SITE PLAN AMENDMENT - SPAA-001050-2019

SPECIAL REVIEW USE - SRU-001049-2019

SITE PLAN AMENDMENT NO.1

PUBLIC SERVICE COMPANY OF COLORADO
230 KV NEIGHBORHOOD ELECTRIC SUBSTATION
COVER SHEET
SITE PLAN AMENDMENT - SPAA-001050-2019
SPECIAL REVIEW USE - SRU-001049-2019

DRAWING TITLE:
SUBSTATION ELEVATIONS

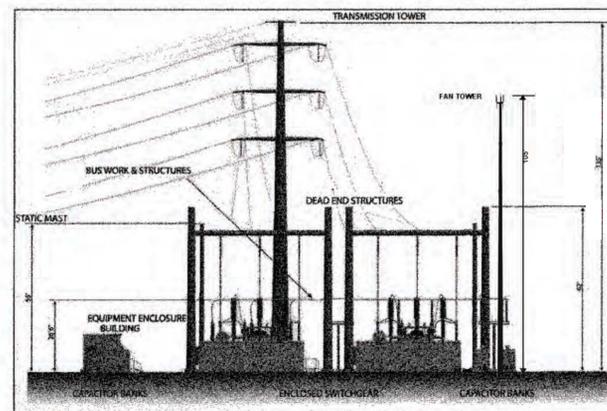
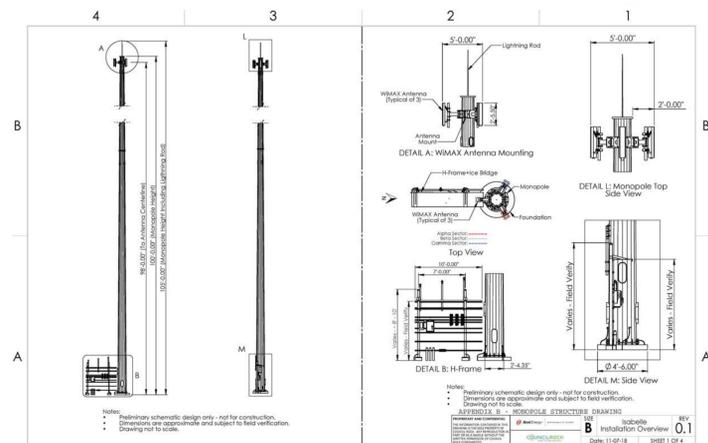
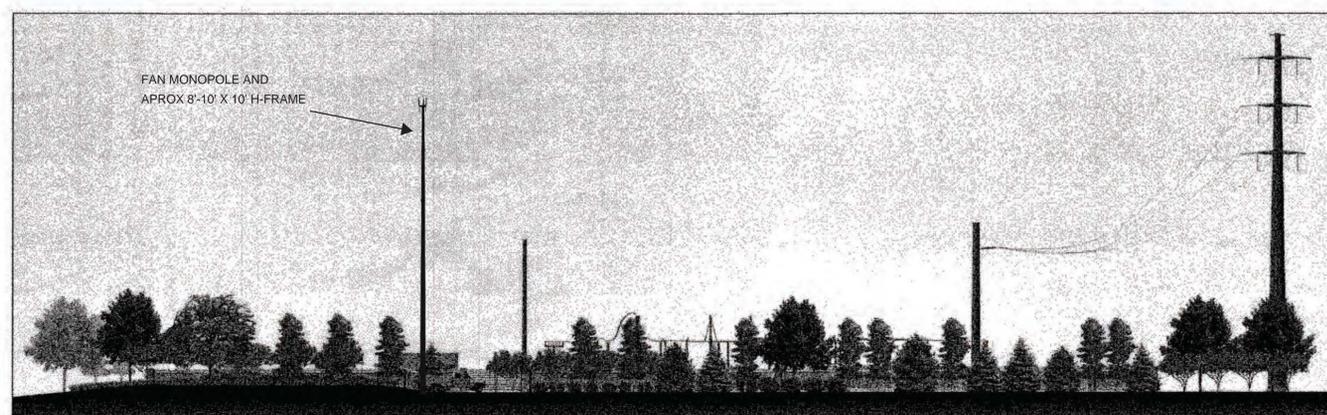
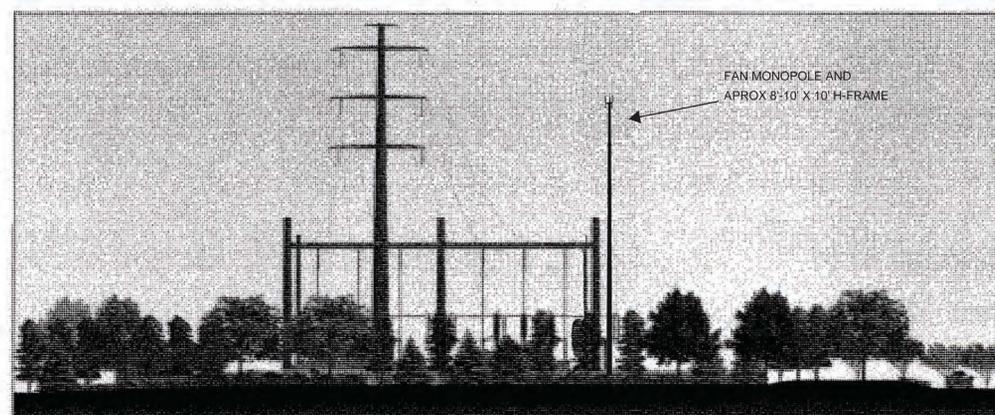
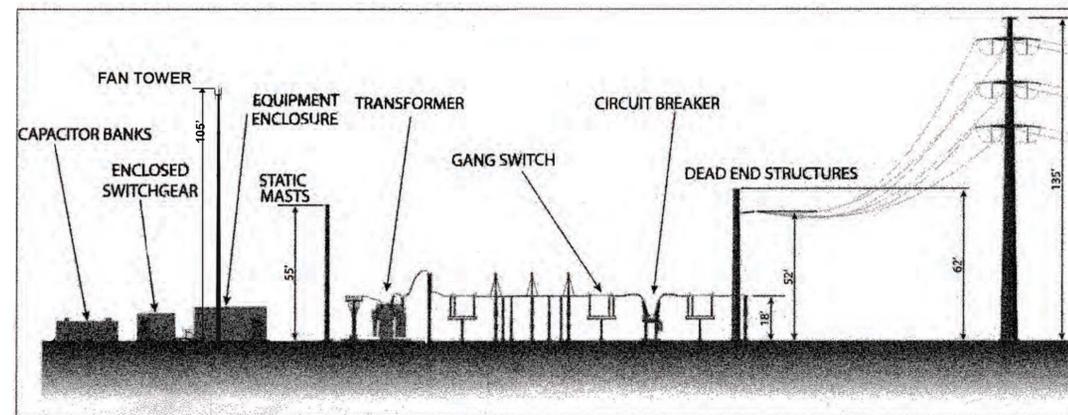
NOTE:
1. TRANSMISSION TOWER IS APPROVED TO 135 FEET IN SITE PLAN. TOWER WAS ACTUALLY CONSTRUCTED TO 85 FEET.
2. FAN MONOPOLE HEIGHT IS 105 FEET.
